Agenda Item: 650-1097

Title: API-620 Outlet Allowance

Purpose: To allow the use of studded outlets as shown in API-620 figure.

Studding Outlet (Option 1)

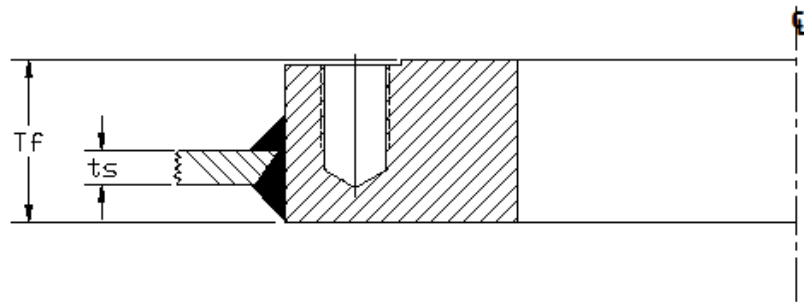
Add sketch to Figure 4.3

Studding Outlet (Option 1)

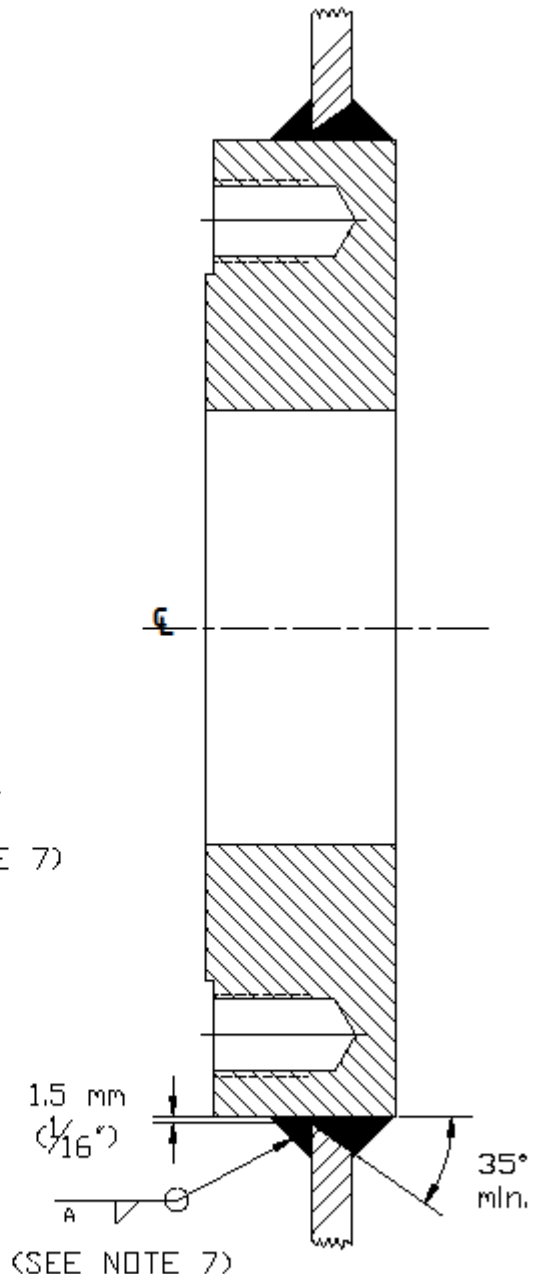
Add sketch to Figure 5.8
